COMMISSION OF ARCHITECTURAL REVIEW
APPLICATION / CERTIFICATE OF APPROPRIATENESS

Address 2620 East Grace Street, 23223
Historic District St. Johns

**From:** [Tim May](#)  
**To:** [Pitts, Marianne G. - PDR](#); [Jonathan Contractor Bean](#)  
**Cc:** [Chen, Kimberly M. - PDR](#); [Rachel May](#); [Jeffries, Chelsea R. - PDR](#)  
**Subject:** Re: 2620 East Grace Street - Timothy & Rachel May  
**Date:** Wednesday, September 13, 2017 10:37:45 AM

DEMO PLAN

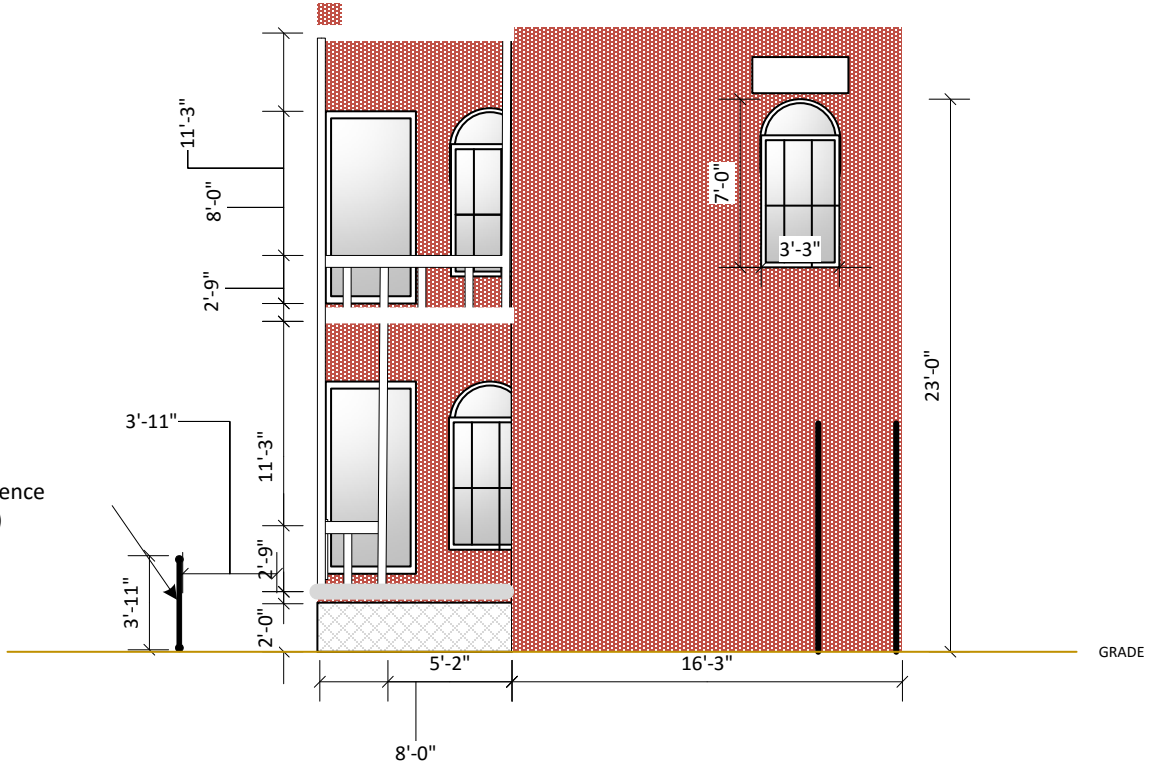
- Project description
- Pictures of existing conditions
- Accurate existing floor plans. As we discussed, there appears to be some windows missing. Additionally, the area that your proposing to enclose projects past the existing porch which is not accurately shown on the floor plans

- Revisions on the side elevation:
  - If you are not proposing a new fence, I would recommend not including it in your elevation. If you are planning on just painting an existing fence, please state the paint color in your project description. If you are proposing a new fence, we will need a site plan of where the fence will be located, and details of the proposed fence to include dimensions and materials.

"...existing floor plans" - **Reply - See attached**

"Additionally, the area that your proposing to enclose projects past the existing porch which is not accurately shown on the floor plans" - **Reply - Unless I am not understanding Marianne's statement, the proposed enclosure does not project past the existing porch. We are only enclosing the part of the side porch that already is there.**

o If you are not proposing a new fence, I would recommend not including it in your elevation. If you are planning on just painting an existing fence, please state the paint color in your project description. If you are proposing a new fence, we will need a site plan of where the fence will be located, and details of the proposed fence to include dimensions and materials. **Reply - New front fence will be a cast iron fence, no higher than 3 1/2 feet.**

Elevation

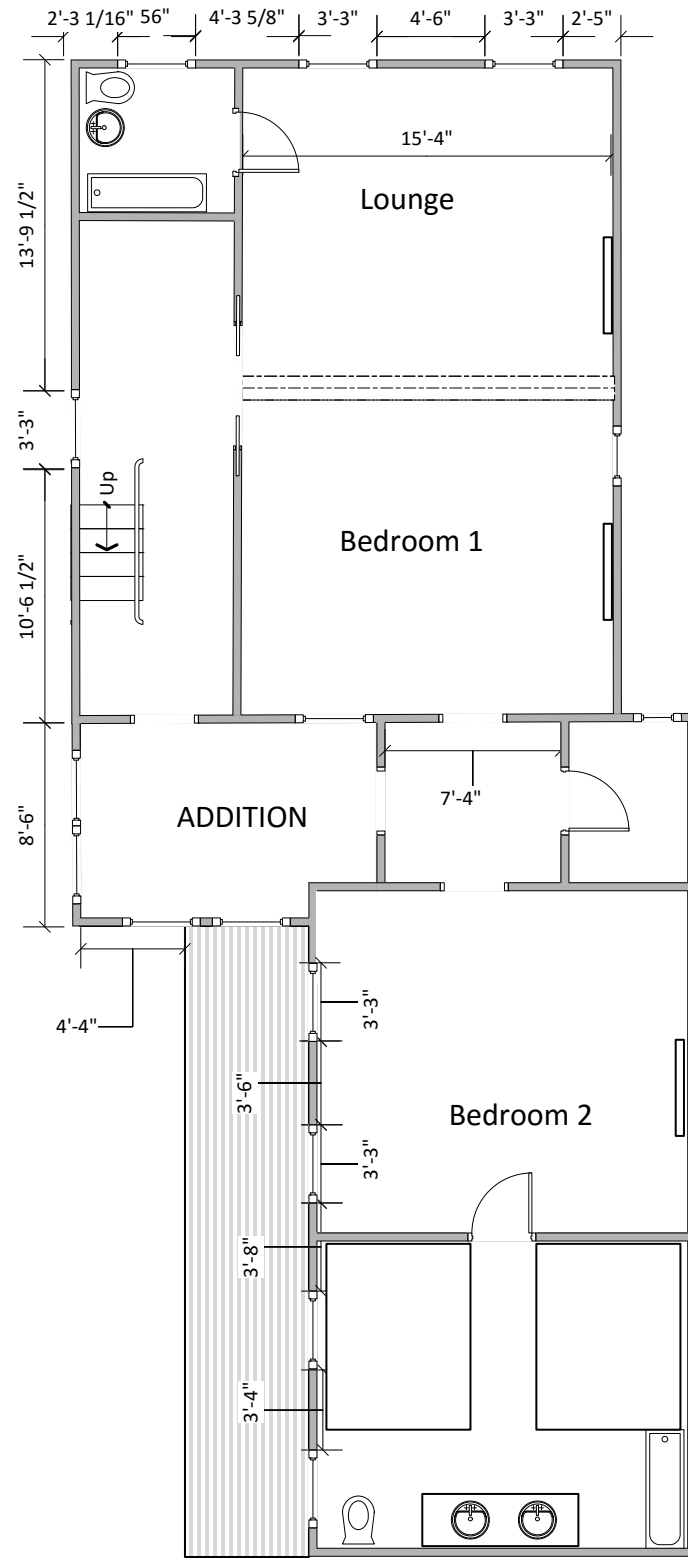
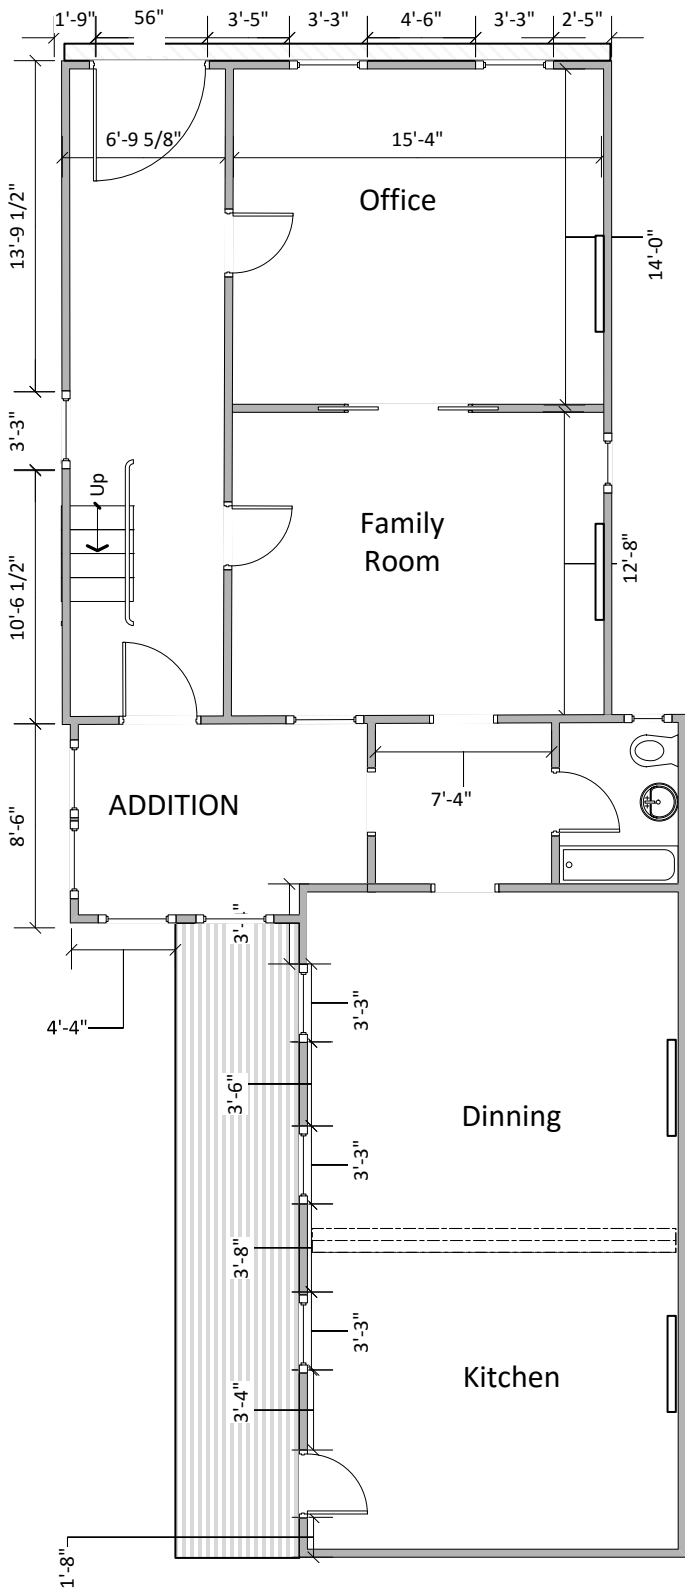
- Mr Bean...on the side and rear drawings, please show that the 2 Windows are two separate, individual Windows. The current drawing doesn't give a clear depiction that it is 2 Windows. It looks like it is one big window. So please separate the 2 Windows by showing an indentation between the 2.

- Dimensions on the proposed addition for the windows and vertical dimensions for the addition
  - Material description for the window and cladding. The Commission does not approve vinyl siding or vinyl windows. They do approve fiber cement or wood siding and wood or aluminum clad wood windows.

- Are you proposing a different cladding or paneling below the 2<sup>nd</sup> story window? For porch enclosures, the Commission typically likes details similar to those provided in your examples or including railings and columns similar to the existing porch details.

o Dimensions on the proposed addition for the windows(**Reply - 2'9" X 6' - width X height**) and vertical dimensions for the addition(**Reply - 10'5"**)

o Material description for the window and cladding. The Commission does not approve vinyl siding or vinyl windows. They do approve fiber cement or wood siding and wood or aluminum clad wood windows. (**Reply - Wood siding and wood clad windows**)

- Are you proposing a different cladding or paneling below the 2<sup>nd</sup> story window? For porch enclosures, the Commission typically likes details similar to those provided in your examples or including railings and columns similar to the existing porch details. **(Reply - Same cladding and paneling for both stories of enclosure and will be the same color as the existing/current columns which can be found on the attached "Existing Condition 3" photo.**
- The plans note "All new windows per CAR." I believe you are only talking about the windows on the enclosure, but please clarify. **(Reply - Correct, all windows will be the same as current. The "new" windows are for the enclosure with dimensions 2'9" X 6')**
